RECORD PLANS

PROPOSED IMPROVEMENT
 BRIDGE PROJECT

PROJECT NAME: MENDON
 PROJECT NUMBER: BRO 1443(43)

51+80

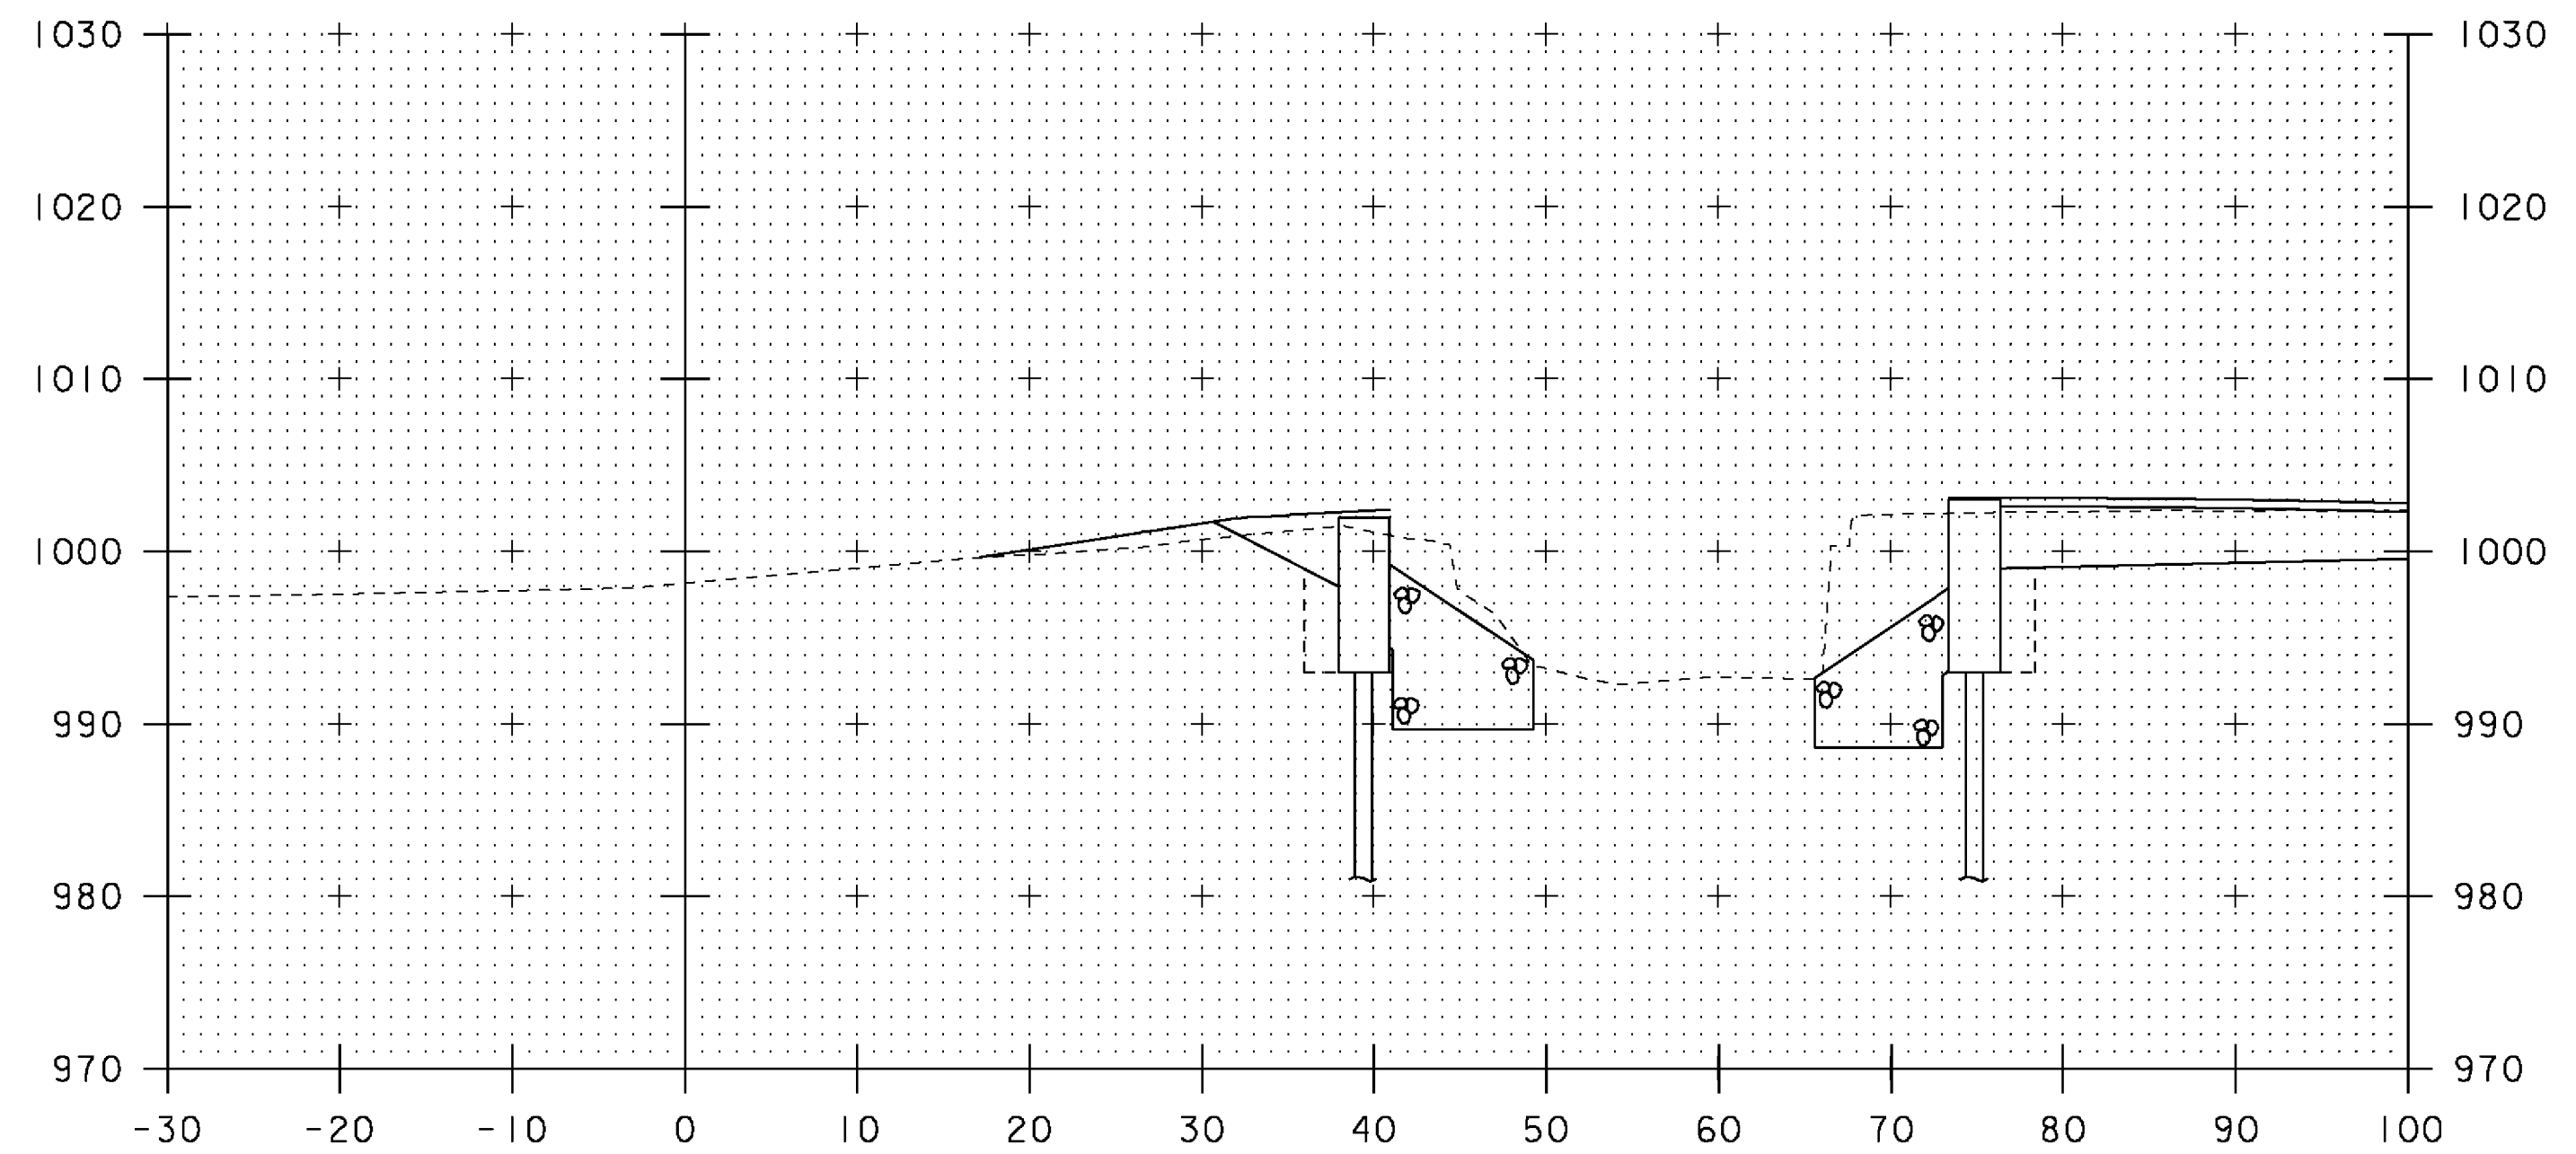
EXISTING GROUND NO LONGER VALID SINCE IRENE 8-28-II.
 NEW SURVEY REQUIRED FOR CHANNEL SECTIONS
 (TYP ALL SHEETS 31 & 32).
